**Re: Union Gas Limited (“Union”)
2017 Panhandle Replacement (Jefferson)
EB-2017-0118**

This letter will update the Ontario Energy Board regarding the proposed route of the 2017 Panhandle Replacement (Jefferson), located in the City of Windsor.

Union Gas Limited – 2017 Panhandle Replacement Pipeline Project

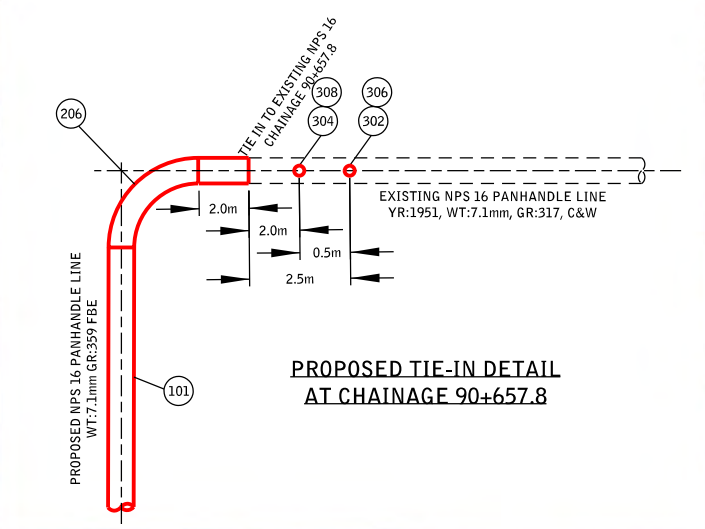
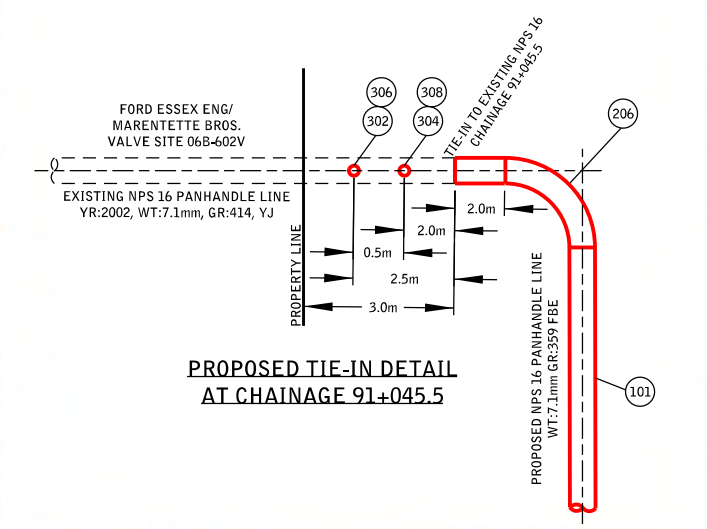
Attached please find two maps showing the revised location of the proposed facilities and a letter for the Airport agreeing with the new location of the proposed pipeline.

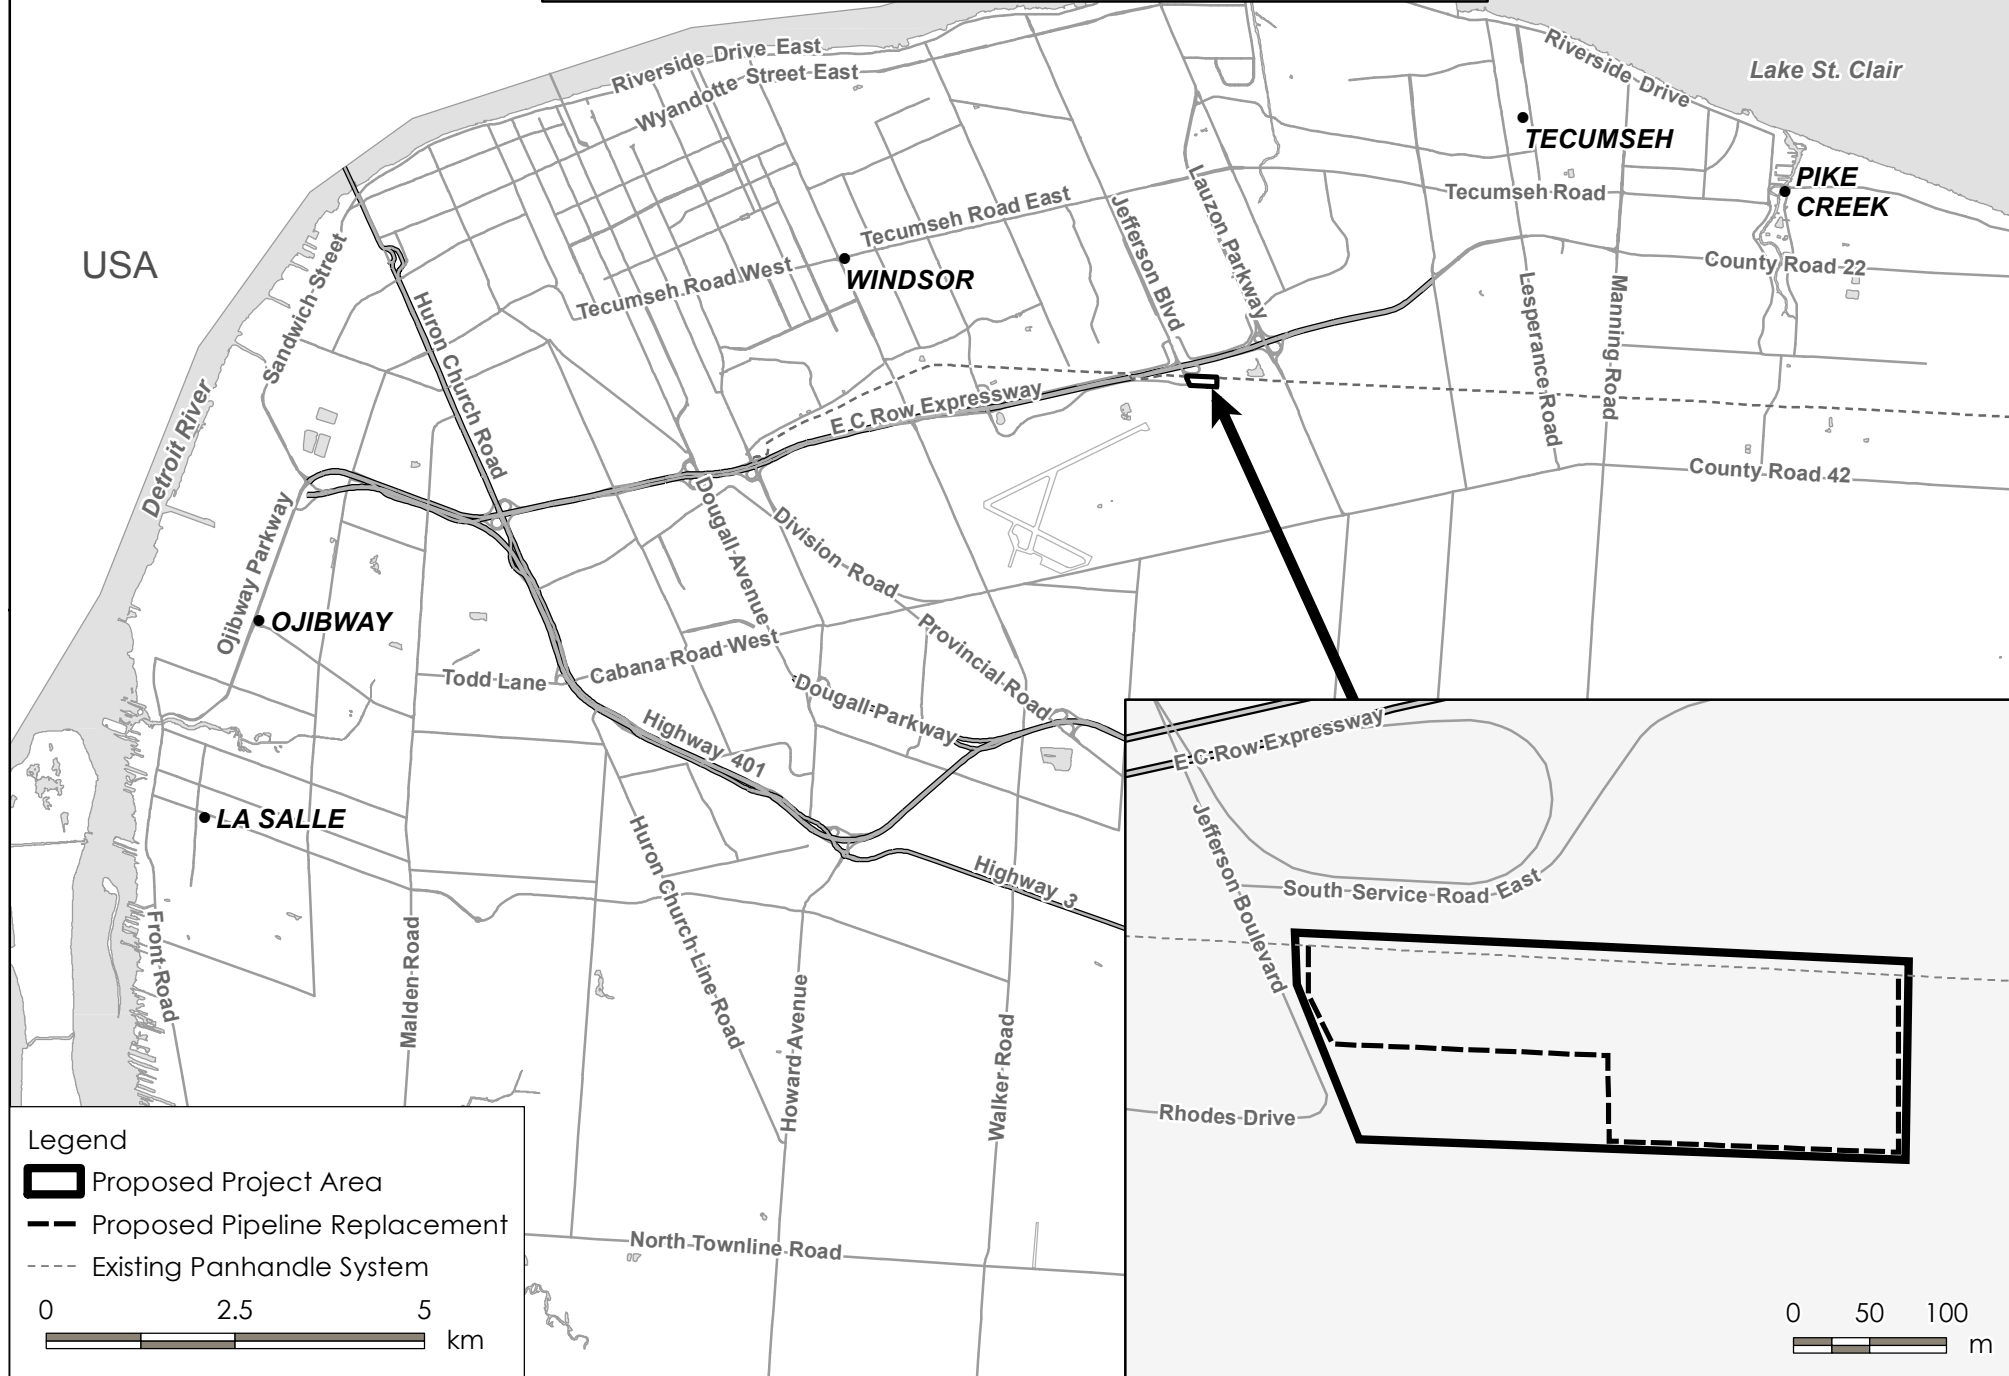
1	MR. 23	N.N.	T.J.	ADJUSTED RUNNING LINE FOLLOWING NEW REQUESTS FROM STAKEHOLDERS
No.	DATE	BY	APP'D	REMARKS
REVISIONS				
 An Enbridge Company				
JEFFERSON BLVD. CLASS LOCATION NPS 16 PANHANDLE REPLACEMENT PROJECT ALIGNMENT DRAWING				
DRAWN BY: K.N. GUERIN	DATE: 2017/03/23	PLOT SPEC: 1/600		
CHECKED BY: AL AMRY	DATE: 2017/03/23	CAD CODE: PL1036-02 Ver02-NN		
APPROVED BY: T. JONES	DATE: 2017/03/23	FILE REVISION DATE: 2017-03-23		
GRID No. 1 OF 1	SYS	DRAWING No. PL1036

After reviewing your proposal to replace the NPS 16 pipeline to the east of Jefferson Blvd., YQG, has no objection to the location described by Drawing PL1036 Revision 1 – March 23, 2017 (attached), or to the construction methodology proposed by Union Gas; provided that the pipeline is buried to a minimum of 60" below grade, backfilled with sand layer and marked with safety tape inside of the trench.
